**SUBJECT:** NuScale Power, LLC Supplemental Response to NRC Request for Additional Information No. 83 (eRAI No. 8899) on the NuScale Design Certification Application

NuScale Supplemental Response to NRC Request for Additional Information eRAI No. 8899

## **Response to Request for Additional Information Docket No. 52-048**

Figure 19.1-42: Simplified Reactor Building Section View

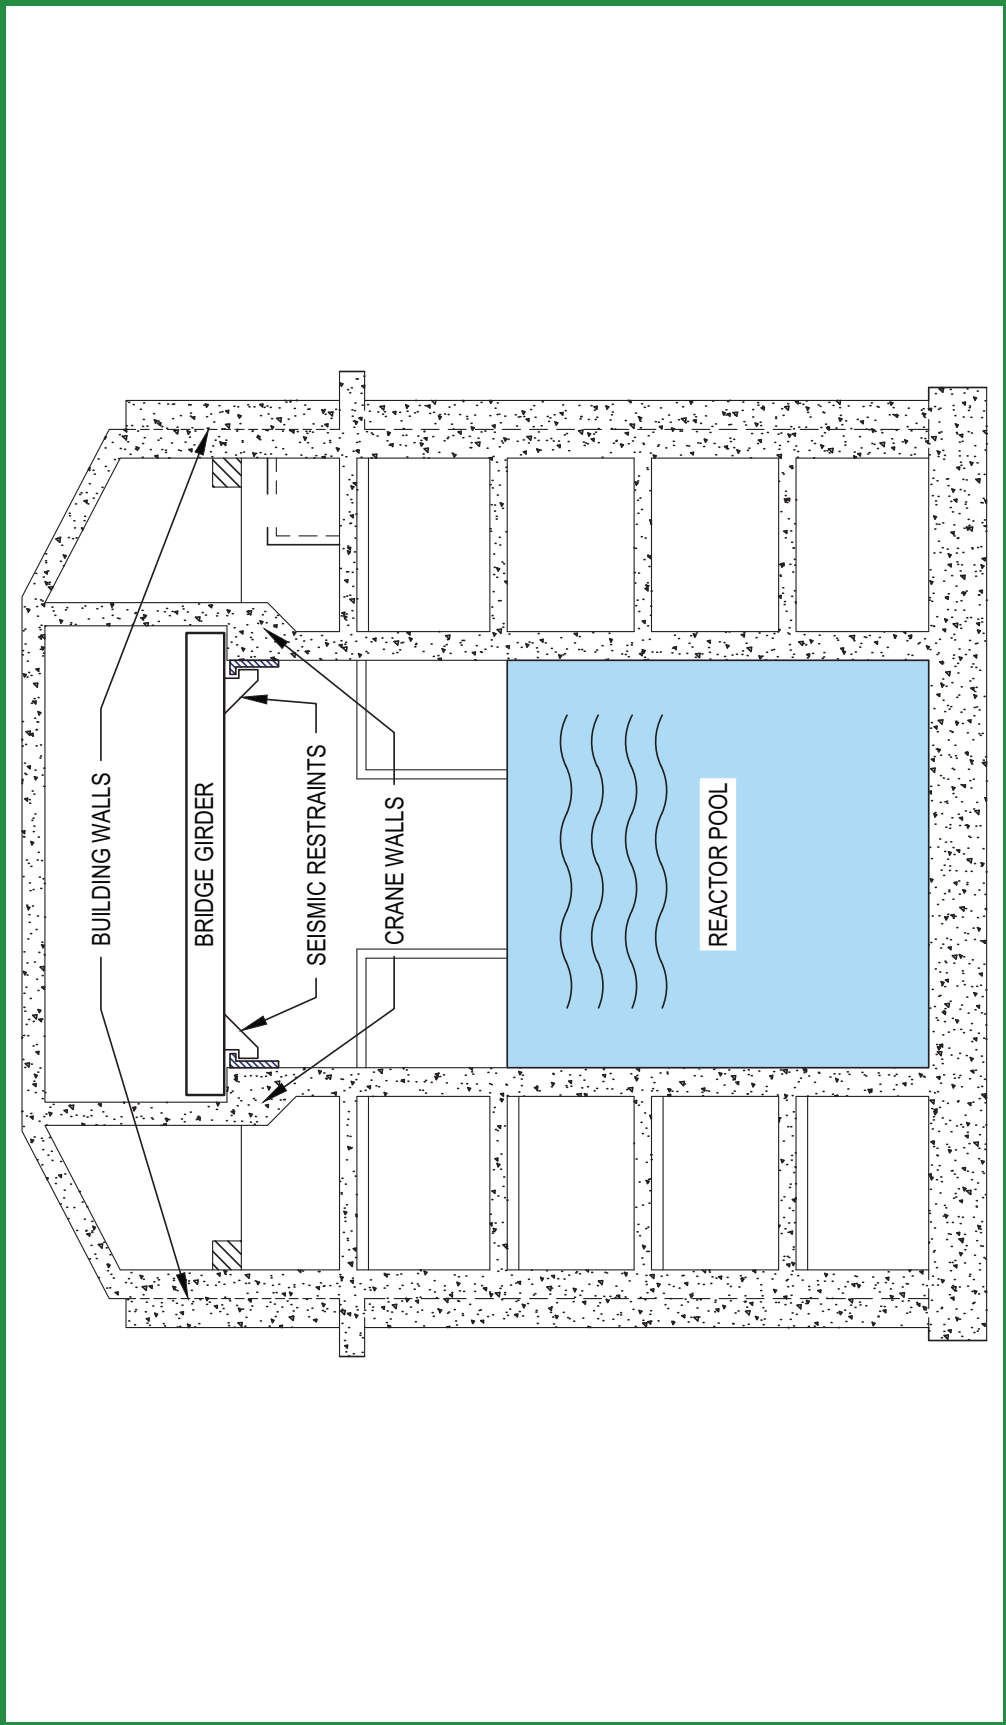
During its audit of the PRA (ML17087A109), staff reviewed ER-P040-7026-R0, “Seismic Margin Assessment Notebook,” Appendix J. The applicant summarized the contractor-supplied fragility calculations for PRA-critical SSCs. The staff identified differences between the contractor-supplied HCLPF capacities for the RBC. The results are summarized below.

The HCLPF capacity provided in the FSAR corresponds to the higher HCLPF capacity (in row 1 above) supplied by the contractors. The failure modes considered are for the bridge and trolley seismic restraint assemblies. The controlling HCLPF capacity is determined to correspond to the seismic bridge restraint weldment.

A note is provided below Table J.10 in relation to the lower HCLPF capacity (in row 2 above). The note states that “The fragility for the reactor building crane is with respect to a bridge girder failure in shear. Upon further evaluation, catastrophic bridge girder failure will be preceded by bridge seismic restraint failure. Due to this realization, failure of the bridge seismic restraints are the controlling failure mode, rather than the bridge girder.” This information is also summarized in Section 19.1.5.1.1.3, Subsection “Reactor Building Crane.”

Based on the staff’s review of ER-P-040-7026-R0, Appendix J, during its audit of the PRA (ML17087A109), the staff needs additional information to understand the basis for eliminating bridge girder failure in shear as a controlling failure mode for the RBC fragility evaluation. Because the RBC is PRA-critical and controls the plant level HCLPF capacity, the staff requests that the applicant provide further justification for eliminating the bridge girder failure in shear in the RBC fragility evaluation.

NuScale has evaluated the potential for "bridge girder failure in shear" as well as "catastrophic bridge girder failure". Girder failure in shear implies that the girder exhibits inelastic deformation, but remains on top of the crane walls because of the span of the girders. Fragility for the bridge girders is calculated up to the yield strength of the girder materials. Any induced buckling or torsion short of complete girder shearing, while potentially rendering the crane inoperable, cannot cause the bridge structure to collapse as long as the seismic restraints hold.

Catastrophic bridge girder failure is associated with a seismically-induced vertical jumping motion that is sufficient for the crane bridge to decouple from the rail and slide off the crane wall ledges; the seismic restraints are designed to resist this motion. Analysis shows that seismic restraint failure is the controlling seismic failure mode for the crane collapse and, thus, is reported as the controlling failure mode in FSAR Section 19.1.5.1.1.3 and FSAR Table 19.1-35.

FSAR Section 19.1.5.1.1.3 has been modified to reflect consideration of both failure modes. FSAR Figure 19.1-42 has been added to illustrate the bridge girder, crane wall ledges and seismic restraints.

Figure 19.1-42 has been added to the FSAR and FSAR Section 19.1.5.1.1.3 has been revised as described in the response above and as shown in the markup provided in this response.

The crane is designed with seismic restraints. ~~Catastrophic~~ As illustrated in Figure 19.1-42, -bridge girder failure is preceded by failures of these bridge seismic restraints through yielding of the restraint weldments ~~bridge girder failure cannot lead to catastrophic collapse without failure of the bridge seismic restraints.~~ Therefore, failure Failure of the bridge seismic restraints is the controlling failure mode by comparison to yielding of the bridge girder itself. The bounding consequence of crane failure is a collapse of the crane structure, which is assumed to impact the top of the module, and lead to core damage and large release. This modeling simplification is ~~required~~ conservative because the bioshield, CNV and RPV integrity are not credited following a crane collapse.
